Ohio Power Siting Board

Staff Investigation Report and Recommendation

Case No.: 11-1995-EL-BGA

Project: Amendment to Blue Creek Wind Farm Certificate of Environmental Compatibility and Public Need

11-1995-EL-BGA
amendment to
09-1066-EL-BGN
Blue Creek Wind Farm

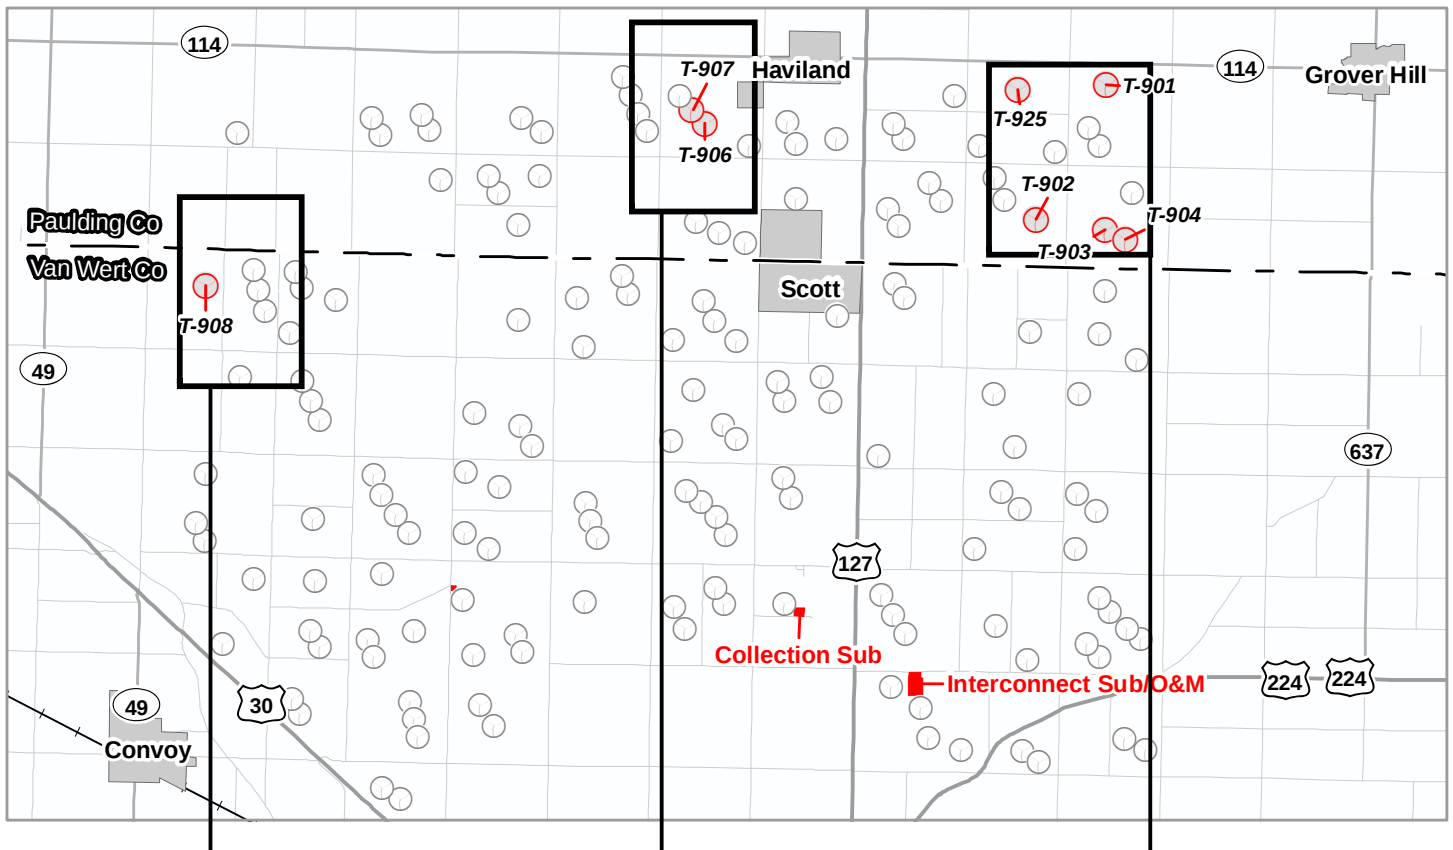
The proposed project amendment involves the construction and operation of eight additional Gamesa G-90 model 2.0 Megawatt (MW) wind turbines at the Blue Creek wind farm. Blue Creek wind farm is currently under construction in accordance with the Opinion, Order, and Certificate (Case No. 09-1066-EL-BGN) that was issued on August 23, 2010. The locations of these eight additional turbines and associated facilities are shown on the map in this report.

The amended project area covers the same 40,500 acres located in Blue Creek, and Latty townships in Paulding County and Tully, Union, and Hoaglin townships in Van Wert County that were identified in the original certificate. The facilities in the amended project area will be located on approximately 24,900 acres of leased private land with approximately 200 participating landowners. The original certificate identified 17,000 acres of leased private land and 106 participating landowners. The locations of these eight additional turbines and associated facilities are shown on the map in this report.
